Product Change Notification (PCN)

PCN Number	506476	Date Issued	March 05, 2019
Reason for Change	Manufacturing Process Change (Molex)		
Change Type Description	This letter is to inform you that the manufacturing process for the part(s) identified in this notice is changing. No changes will be made to the product as a result of this process change.		
Reason for Short Notice	Special Request		
Assessment of Change	Product will be fully qualified before it is shipped. Qualification reports will be available after below listed date		
Internal Molex Qualification Date	December 10, 2018		
Sample Availability Date (Changed Part)	December 10, 2018		
Planned Implementation Date	March 30, 2019		
Method of Identifying Change	Date code

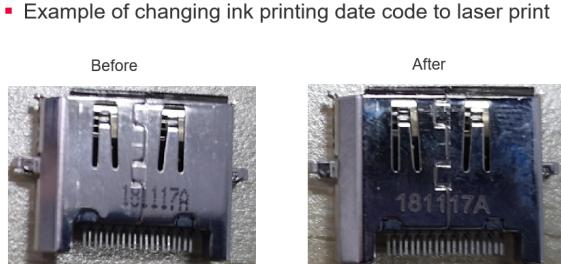
- To better protect environment and improve process efficiency, Molex is planning to change the ink printing date code to laser print date code.

- No change to product, no impact to fit, form or function.
